**Re: EB-2020-0061 Application for May 1, 2021 Electricity Distribution Rates
Wellington North Power Inc.
Applicant's Interrogatory Responses**

**Wellington North Power Inc.'s (Applicant) Interrogatory Responses to
Vulnerable Energy Consumers Coalition (VECC) Interrogatories and OEB staff.**

2021 Electricity Distribution Rates Application

EB-2020-0061

Figure 37: Excluding Loss of Supply – SAIDI and SAIFI Performance for WNP (corrected)

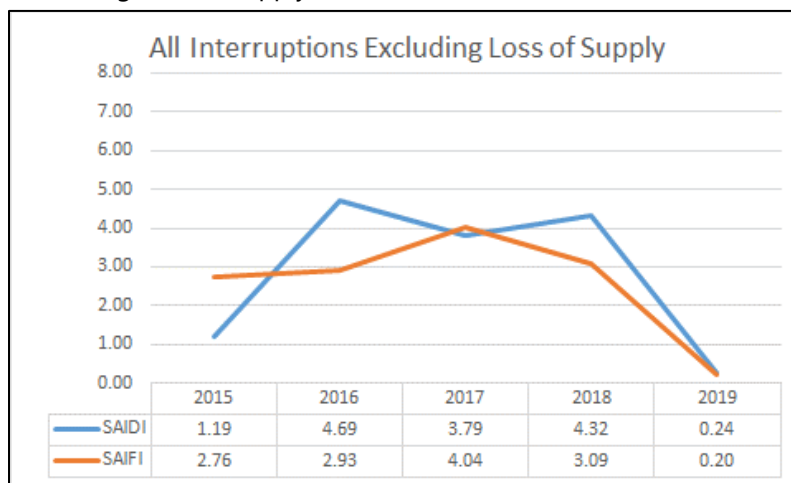
In Figure 37, Wellington North Power states that 2019 System Average Interruption Duration Index (SAIDI) and System Average Interruption Frequency Index (SAIFI) performance excluding Loss of Supply is 0.84 and 2.05 respectively. As there were no Major Event Days (MEDs) in 2019, why is this different from the 2019 scorecard SAIFI = 0.20; SAIDI = 0.24?

The number reported for 2019 was an error. WNP confirms there were no Major Events Days in 2019 and the SAIFI and SAIDI for this year should have been shown as SAIFI = 0.20; SAIDI = 0.24. WNP has corrected Figure 37 of the DSP as per below:
